ISSUE:	Certificate of Appropriateness for alterations
APPLICANT:	Rajat Malhotra
LOCATION:	Old and Historic Alexandria District 211 King Street
ZONE:	KR/King Street Retail Zone

STAFF RECOMMENDATION

2 – Application for BAR 2023-00337 211 King Street

Bollywood Masala - BAR application

Figure 1: Alley elevation upon completion of proposed work

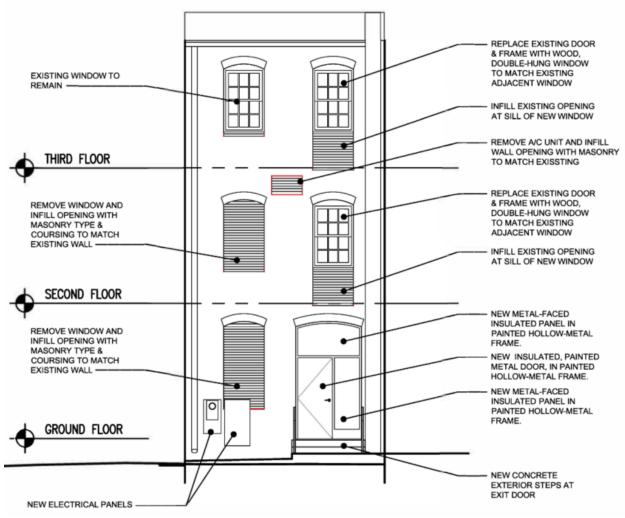
The applicant is modifying the building at 211 King Street to allow for a new restaurant to open in this location. The extensive changes to the building interior are rendering some building components at the exterior of the alley side of the building obsolete. The proposed modifications include the removal of the existing fire escape and the removal of the exposed ductwork. Upon the removal of the fire escape, the second and third floor doors which were originally windows will be restored to the original masonry openings. New masonry infills will take the place of an existing window on the second floor and an existing blank panel on the ground floor. In addition, a through wall mechanical unit is being removed and the brick wall being repaired in its place (Figure 1).

The proposed modifications to the alley elevation of this building will have the overall effect of removing extraneous components and generally cleaning up the elevation. The removal of the fire escape will allow window openings that were previously expanded to serve as doors to be returned to their original proportions. The current ground floor door opening includes a solid double door with mechanical ductwork above. The simple solid door with solid transom panel and sidelight panel is an improvement over the existing condition. In addition to the changes to the building, the applicant is proposing to install new concrete stairs with a simple railing at the door. This will replace the existing sloped concrete at the area and will contribute to the overall simplification of the rear of this property.

At the ground floor, the multi-part blank panel infilling the window will be replaced with a more simple masonry infill. The window to be replaced with a masonry infill on the second floor is not original to the building and staff does not consider this modification to be a significant detriment to the overall elevation. Staff recommends that when the masonry infill is installed in these locations, the new brick be set back from the face of the adjacent brick to allow the masonry opening to remain and express the location of the original windows.

Staff recommends that the Board approve the Certificate of Appropriateness for the proposed alterations with the condition that masonry infill panels of existing window openings be recessed from the adjacent masonry.
